Noncompliant Weld Inspection Techniques

Line 114 Non Destructive Examination Final Report

Issue Date December 5, 2013

Figure 2 – Weld 270 Indication with measurement inset showing length of 0.157” (3.9mm)

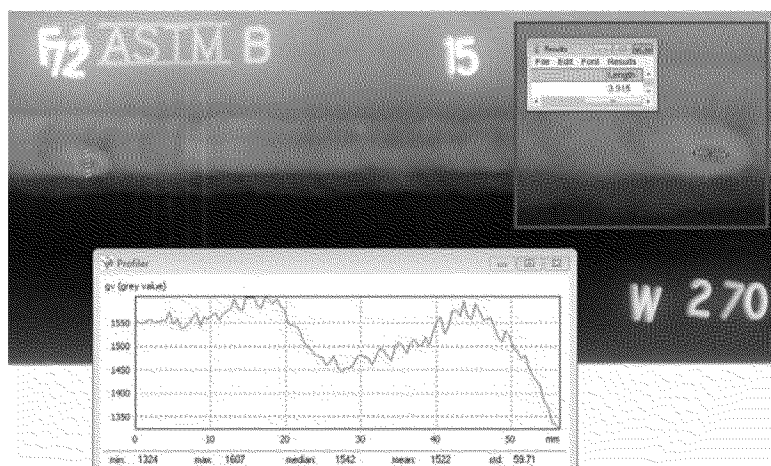
- 3.1 Weld 270, digitized in the region of interest is depicted in Figure 2. Here it can be seen, due to low change in density which is less than the adjacent parent material, and the presence of a halo, that the indication is one of Burn-Through (BT), and is acceptable per section 9.3.7 of API-1104. The weld repair process confirmed this result where the indication was found at the root.

Figure 3 – Weld 311 with acceptable BT length of 0.141” and acceptable small pores

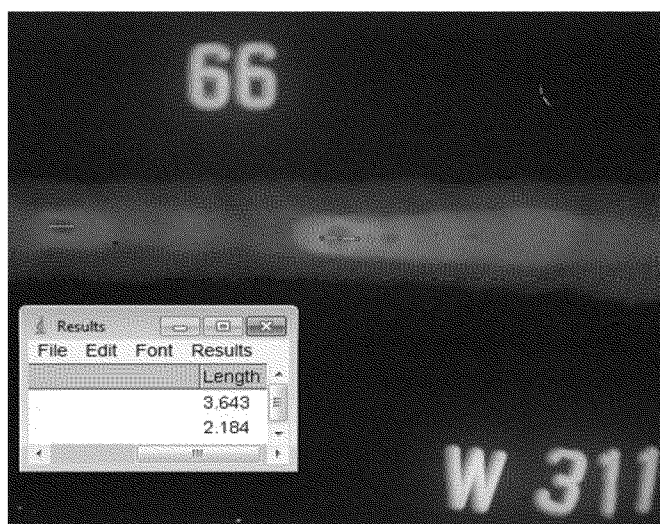
3.2 Weld 311, digitized in the region of interest, is depicted in Figure 3. Similarly we have one indication of burn-through and 3 small pores, all of which are acceptable per sections 9.3.7 & 9.3.9 of API 1104. For both welds 270 and 311, the repair process had to proceed to the root before the indications were eliminated, confirming that they were caused by burn through.

Figure 4 – Weld 162 with acceptable indications of undercut

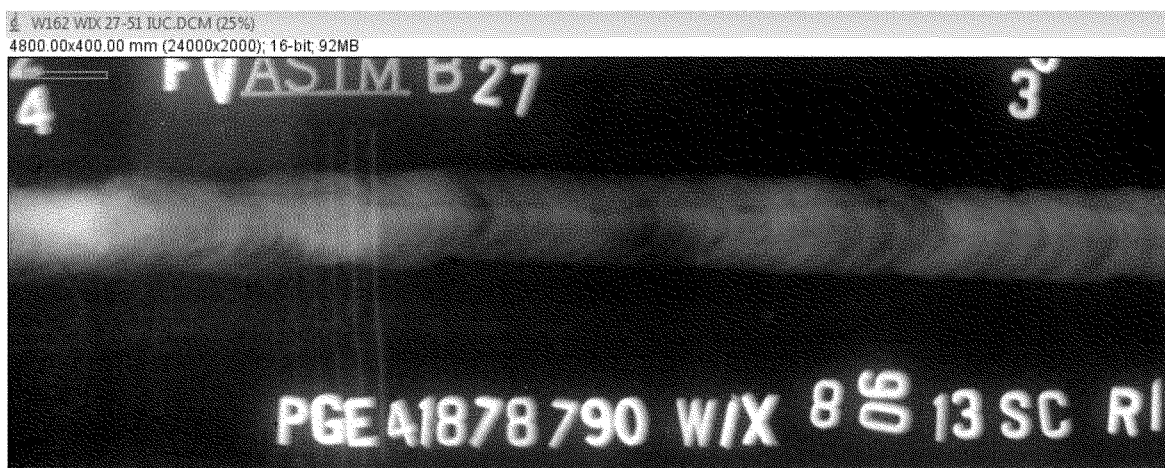
3.3 Weld 162 indication was digitized as shown below in Figure 4. Radiographic density measurements indicate that no portion of the indication has an indication of undercut which is greater than 0.016” deep, indicating that it is acceptable per section 9.3.11& 9.3.7 of API 1104.

Figure 5 – Measured IUC on W162 depicted in Figure 4

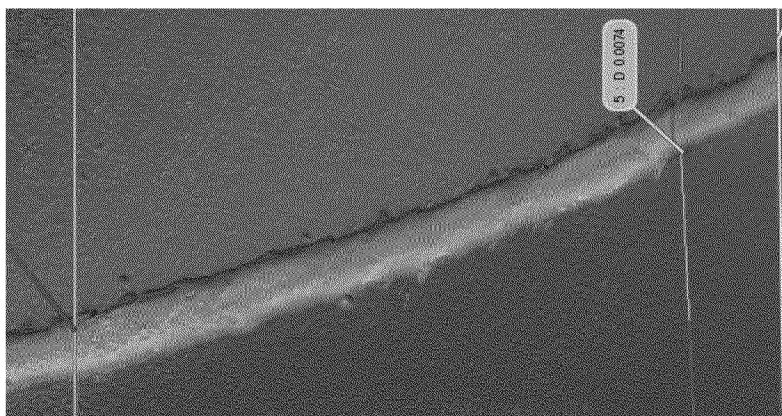
- 3.4 To validate the digital radiographic measurements, external visual, UC gaging and dial indicator measurements revealed that only small areas within the called ROI (25-29) had bottoms estimated below the adjacent parent material surface. Measurements had thus low repeatability due to topography. This result led to the decision for the Creaform photogrammetry with its calibrated 40 micron spatial resolution and accuracy to within 0.002”.
- 3.5 Creaform photogrammetry results were obtained for the radiographic ROI (25-29 in Figure 4). The measurements confirm that no portion of the indicated area of concern radiographically, has a depth greater than 0.016 inches, and is therefore acceptable per sections 9.3.11 & 9.7. Figure 5 below depicts worst case of 0.0074” in radiographic ROI.

Figure 1 – Assessment of Weld 760 IUC region of interest

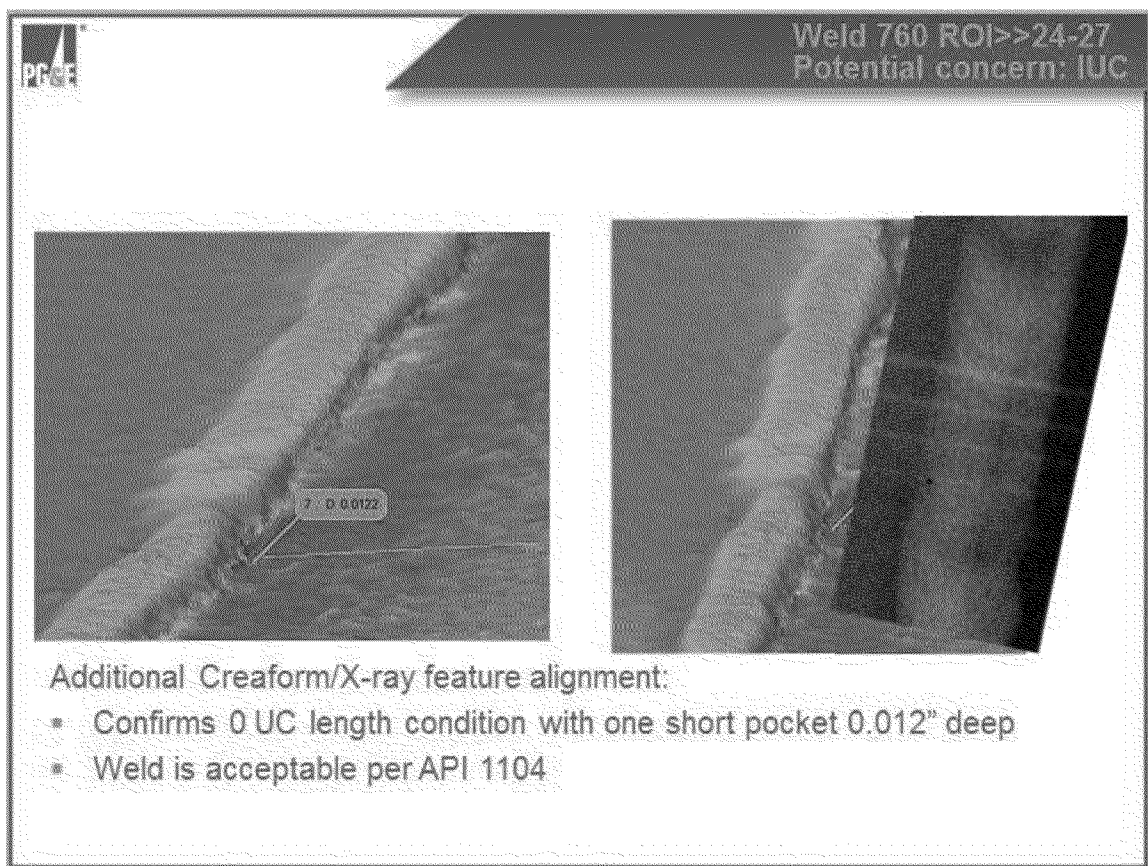
3.5 Creafom photogrammetry results were obtained for all the radiographic ROI's. The criteria applied to these results were API 1104 section 9.7, Table 4, "Maximum Dimensions of Undercutting". Applying the further criteria of depth from this requirement, to the documented radiographic and visual measurement data for length, all welds were found acceptable. Figure 2, from slide 5 in Appendix I, summarizes the typical physical condition for the audit identified indications of concern.

Weld 760 cited for indications of internal undercut from 24-27
Excised weld photo-documented and ROI aligned with weld features
Depth of most severe indications estimated by change in x-ray density

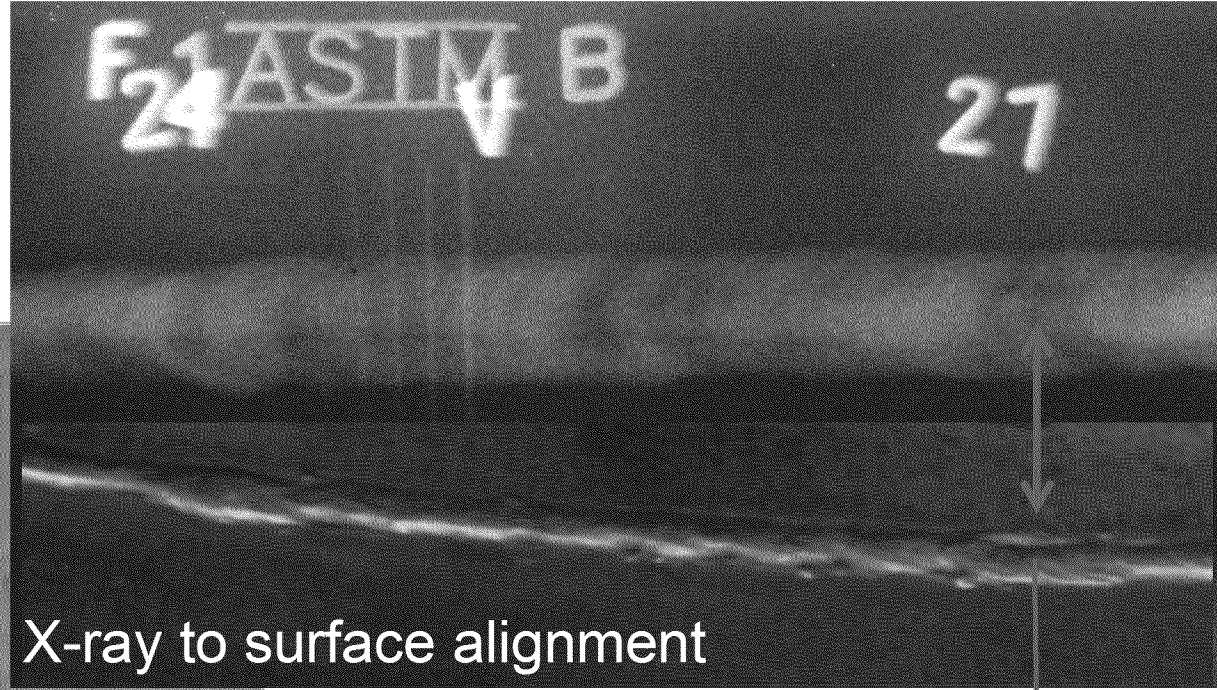
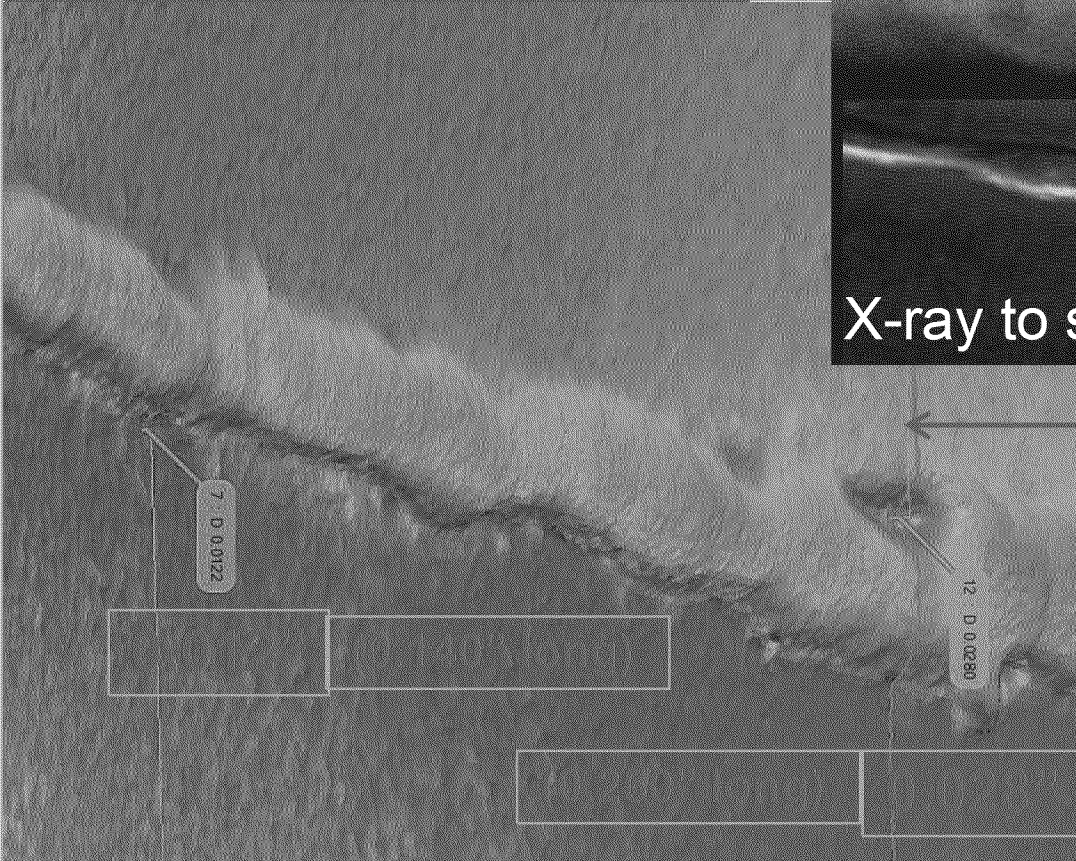
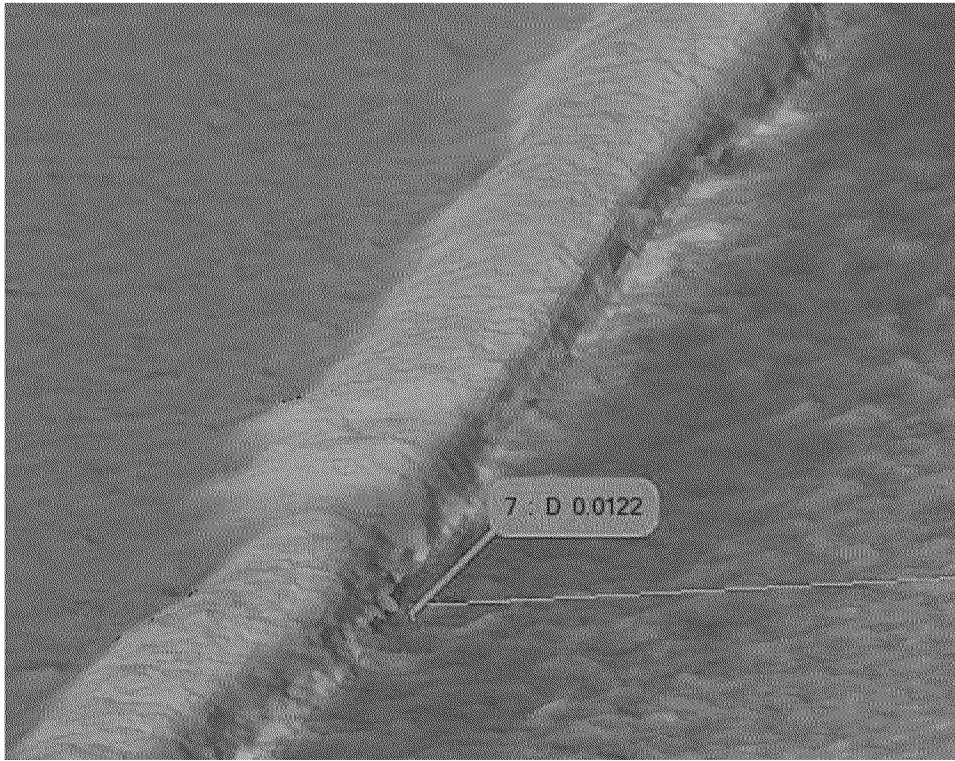
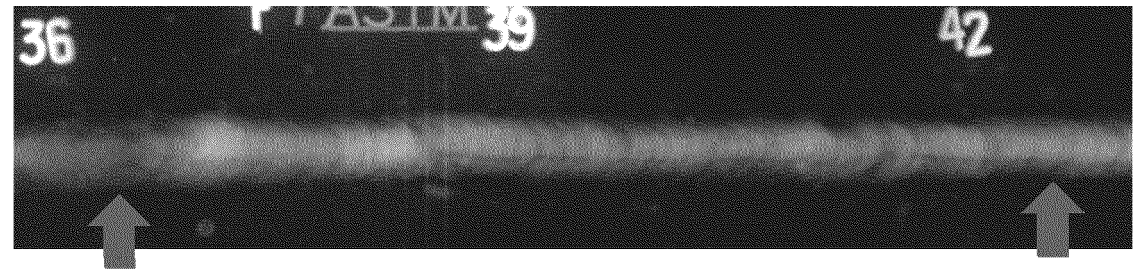
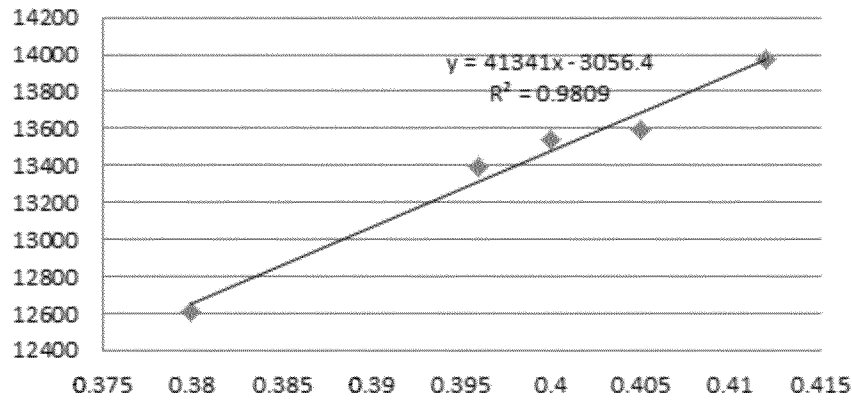
RT estimated depths of 0.012 – 0.028 inches
Further correlation pursued with 3D surface map

Confirms indications are mostly diffraction effects on minor hi/lo condition with 0 UC

Weld is acceptable per API 1104

- * Confirms 0 UC length condition with one short pocket 0.012" deep
- * Weld is acceptable per API 1104

Weld 770 cited for indications of internal undercut from 36-42

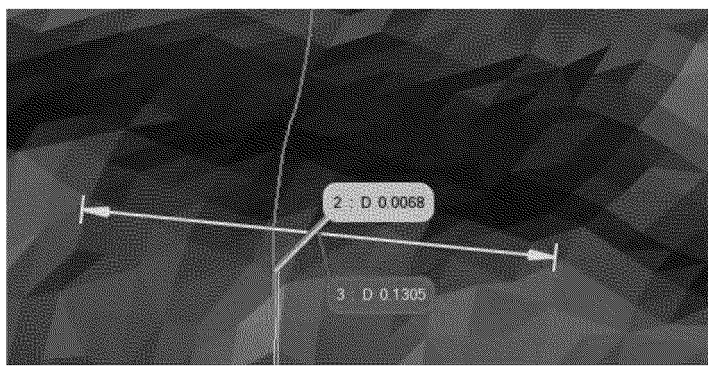
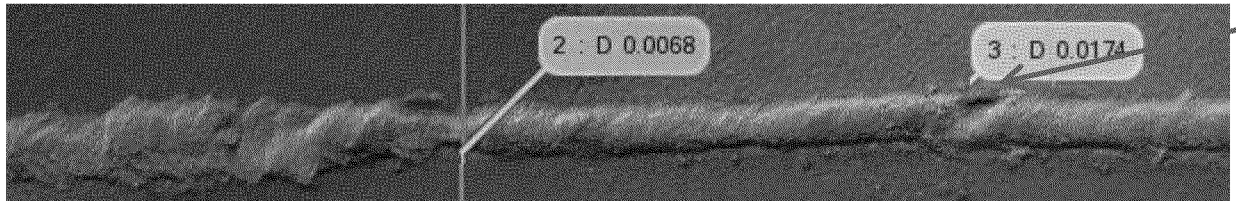
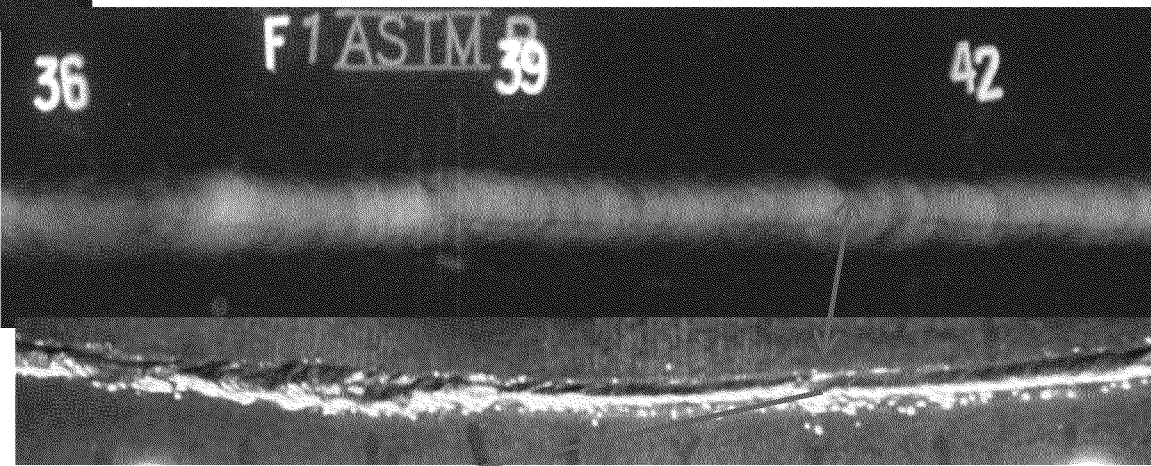
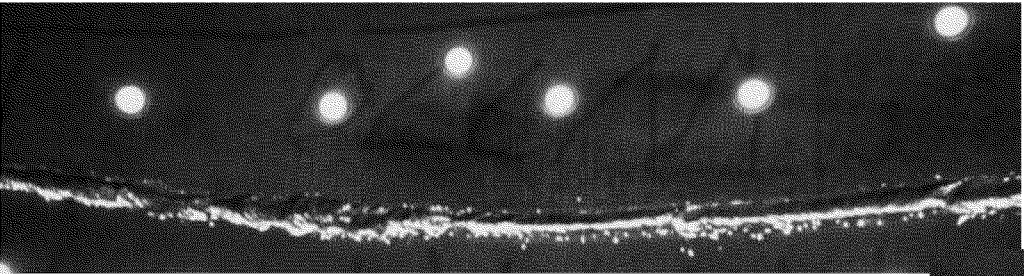
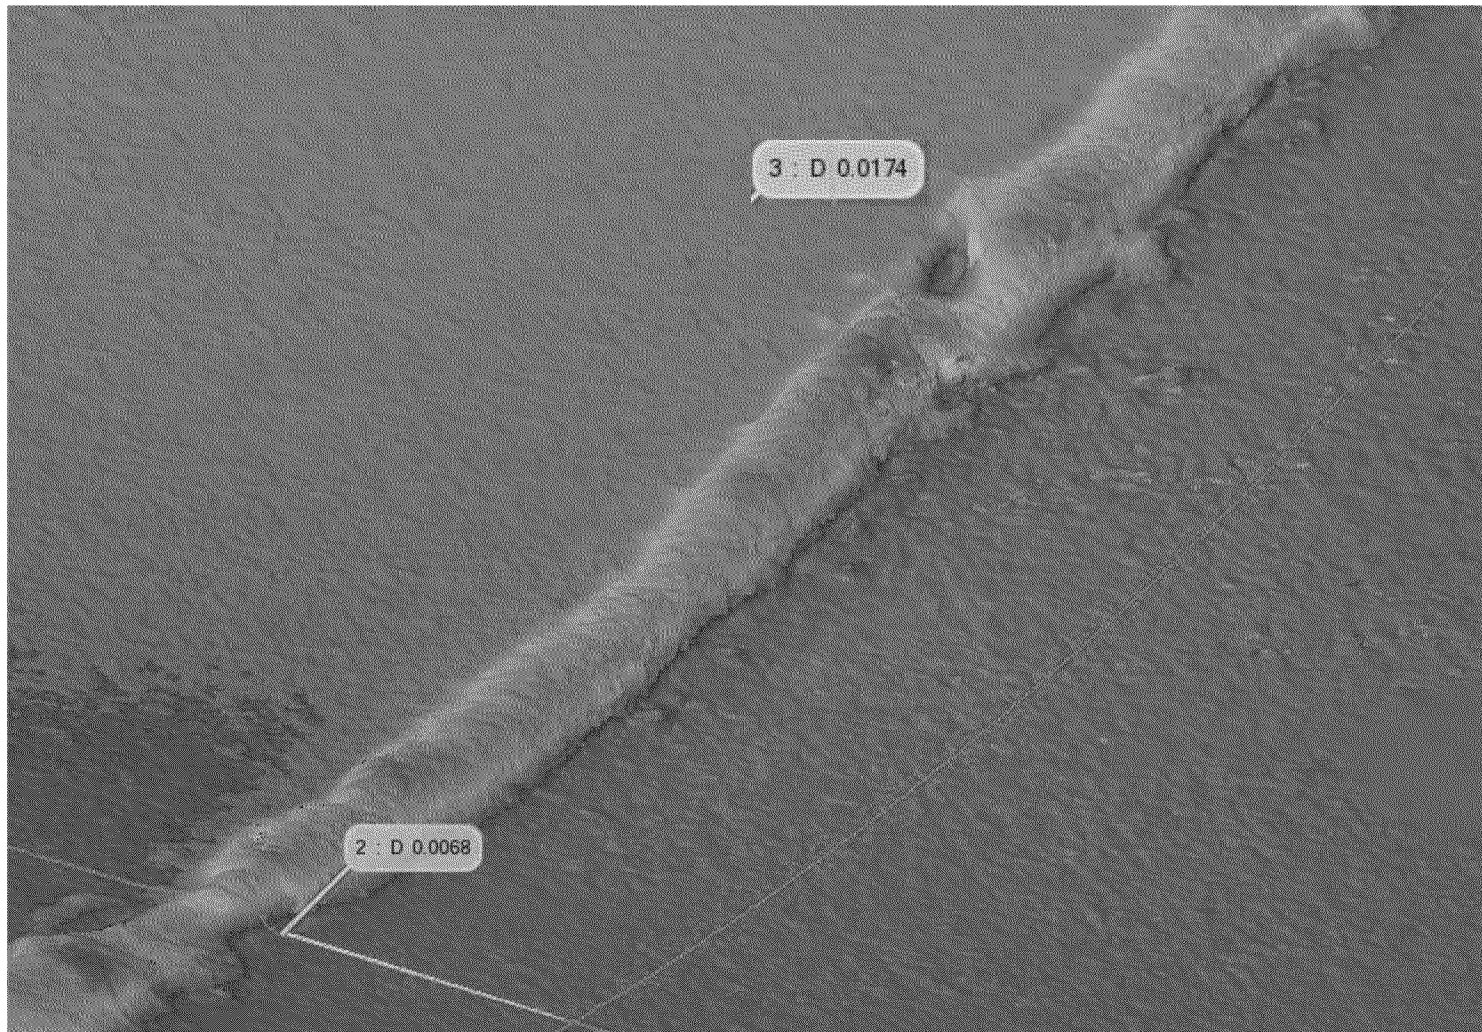
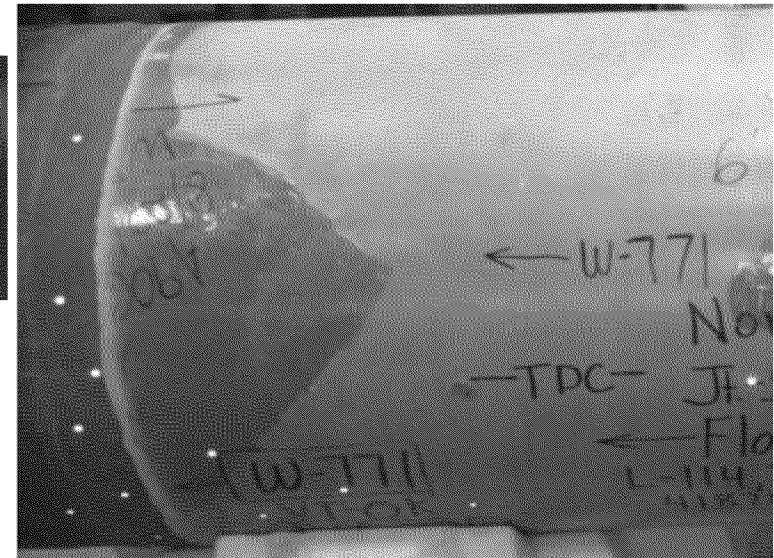
RT estimated depths of up to 0.008 inches

- Confirms indications are, in the majority, diffraction effects on minor hi/lo condition with 0 UC
- One small pocket observed at 0.007" deep x 0.130" long
- One unrelated pocket opposite ROI of 0.017" deep x 0.195" long
- Weld is acceptable per API 1104

- * Confirms UC indication is diffraction/"shadowing" from high/low condition
- * Weld is acceptable per API 1104
